RE: TOYS "R" US GRADING AND DRAINAGE CERTIFICATION (J-19/D48)

RE: DRAINAGE PLAN FOR TOYS "R" US PHASE I (J-19/D48)
RECEIVED JUNE 22, 1988

RE: DRAINAGE PLAN FOR TOYS "R" US PHASE I (J-19/D48)
RECEIVED MAY 17, 1988

RE: CONCEPTUAL GRADING & DRAINAGE REPORT FOR TOYS 'R' US
RESUBMITTED MARCH 25, 1988, FOR SITE DEVELOPMENT PLAN APPROVAL
(J-19/D48)

FIGURE 2 - POND A OUTLET STRUCTURE

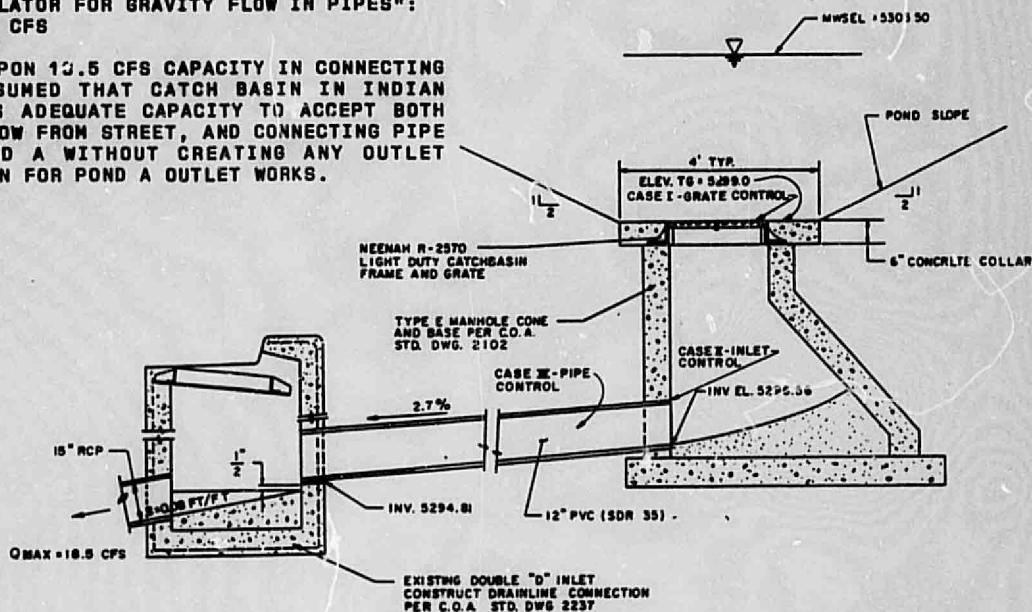
- a detail of the outflow control you are proposing;
- positive drainage for the ponds so that water will not stand;
- low flow channels in Pond B, preferably lined with some sort of dumped riprap; and
- the landscaping treatment for the ponds.

GIVEN: AS-BUILT DRAWINGS INDICATE THAT EXISTING CATCH BASIN CONNECTING PIPE IS 15" DIAMETER RCP WITH $S = 0.080$ FT./F. FROM J-N PIPE "FIELD'S HYDRAULICS CALCULATOR FOR GRAVITY FLOW IN PIPES":
 $Q_{MAX} = 18.5$ CFS

ASSUME: BASED UPON 12.5 CFS CAPACITY IN CONNECTING PIPE, IT IS ASSUMED THAT CATCH BASIN IN INDIAN SCHOOL ROAD HAS ADEQUATE CAPACITY TO ACCEPT BOTH THROUGH GRATE FLOW FROM STREET, AND CONNECTING PIPE FLOWS FROM POND A WITHOUT CREATING ANY OUTLET CONTROL CONDITION FOR POND A OUTLET WORKS.

THEREFORE: IT CAN BE CONCLUDED THAT POND A OUTLET STRUCTURE HYDRAULICS ARE CONTROLLED BY CASE I - GRATE CONTROL, WITH A MAXIMUM FLOW RATE OF 8.2 CFS WHEN POND CRESTS EMERGENCY SPILLWAY AT ELEVATION 5303.50.
